# General Public

## Land Use Plan Map

**From:** Seth Andersen <arete.seth@gmail.com>  
**Sent:** Wednesday, November 2, 2016 12:44 AM  
**To:** Land Use Plan Map  
**Subject:** 2040 plan comments

**RE: Draft Anchorage 2040 Land Use Plan; Forest Park Drive**

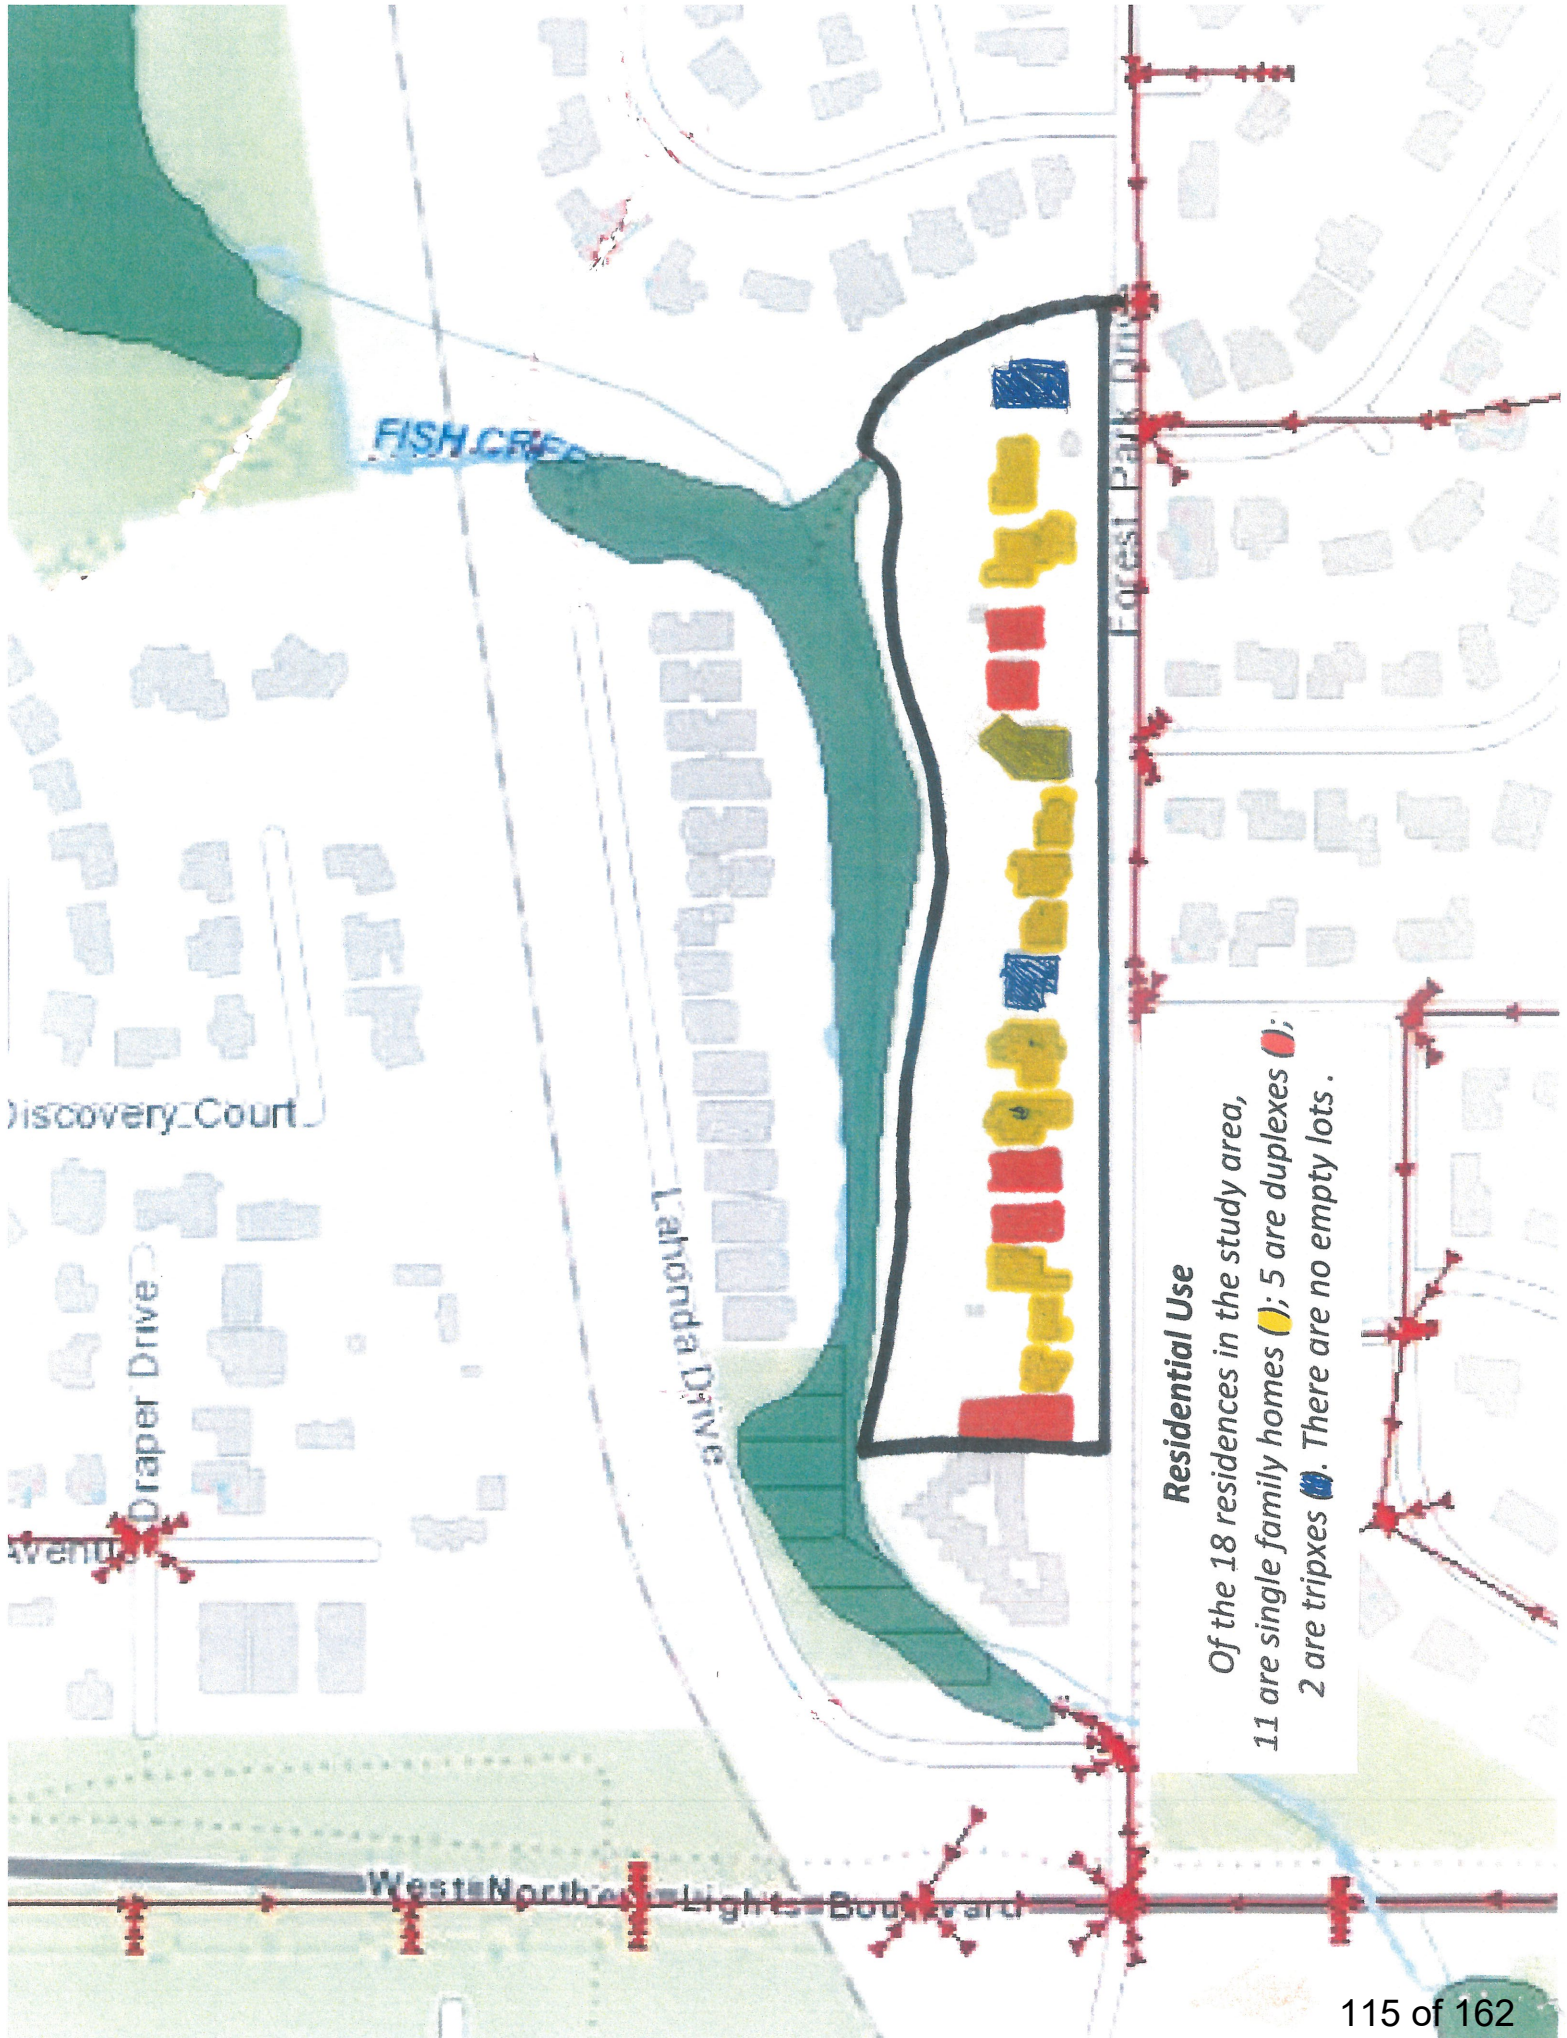
**BASIS FOR ARGUMENT:** The proposed land use designation of Compact Mixed Residential Low is inappropriate on the west side of Forest Park Drive specifically because:

- Higher density residential is not compatible with this residential area;
  - Existing inventory is 1-2 stories, not three
  - Existing inventory is largely single family/duplex, anything larger would overwhelm the “area’s scale”;
  - There are no vacant lots or abandoned buildings in this area so higher density would require destruction of current housing.
- The lots in this area are narrow, long and drop off steeply to the Fish Creek floodplain which limits the actual square footage available for higher unit development.
  - The area is in seismic zone 4
  - Seeps and springs in the slope bordering Fish Creek create unstable soils
  - The designated floodplain boundary prohibits development and location of the required parking areas.
- Higher density residential development will add traffic and create unsafe access/egress conditions

**CONCLUSION:** We request the designation of Compact Mixed Residential Low in the Draft 2040 Land Use Plan be removed from the Forest Park Drive properties and that the area remain designated for Single Family and Two Family structures. This would be in keeping with the area’s existing mixed residential land use and maintain the quality and character of the neighborhood.

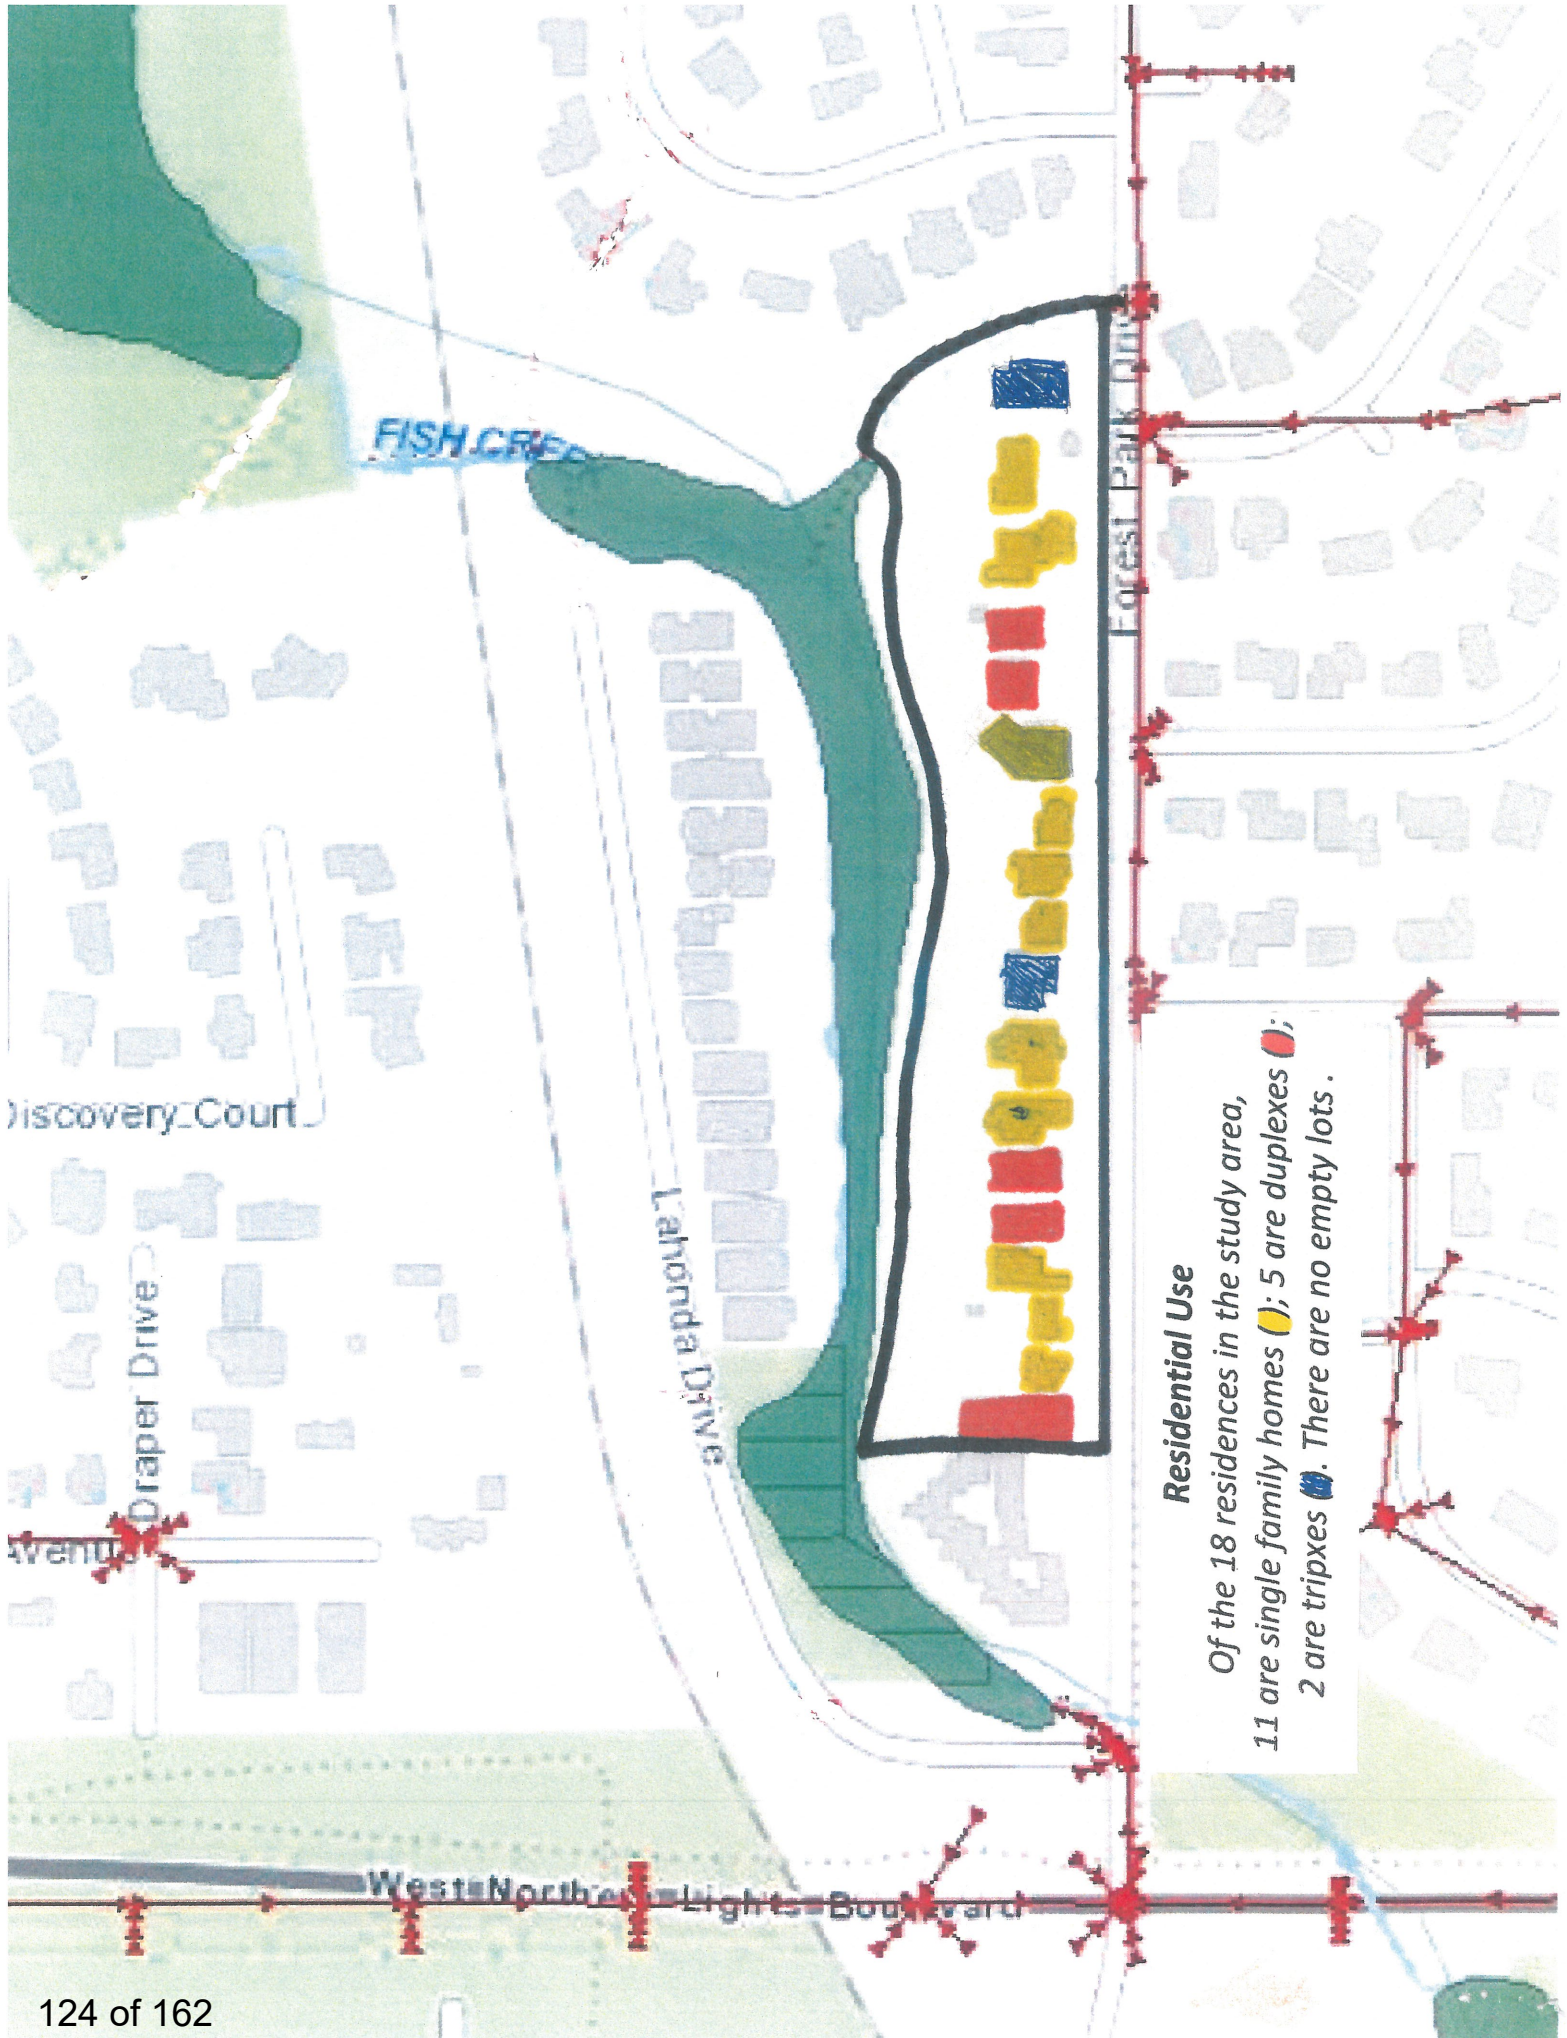
**BASIS FOR ARGUMENT:** The proposed land use designation of Compact Mixed Residential Low is inappropriate on the west side of Forest Park Drive specifically because:

- Higher density residential is not compatible with this residential area;
  - Existing inventory is 1-2 stories, not three
  - Existing inventory is largely single family/duplex, anything larger would overwhelm the “area’s scale”;
  - There are no vacant lots or abandoned buildings in this area so higher density would require destruction of current housing.
- The lots in this area are narrow, long and drop off steeply to the Fish Creek floodplain which limits the actual square footage available for higher unit development.
  - The area is in seismic zone 4
  - Seeps and springs in the slope bordering Fish Creek create unstable soils
  - The designated floodplain boundary prohibits development and location of the required parking areas.
- Higher density residential development will add traffic and create unsafe access/egress conditions

**CONCLUSION:** We request the designation of Compact Mixed Residential Low in the Draft 2040 Land Use Plan be removed from the Forest Park Drive properties and that the area remain designated for Single Family and Two Family structures. This would be in keeping with the area’s existing mixed residential land use and maintain the quality and character of the neighborhood.
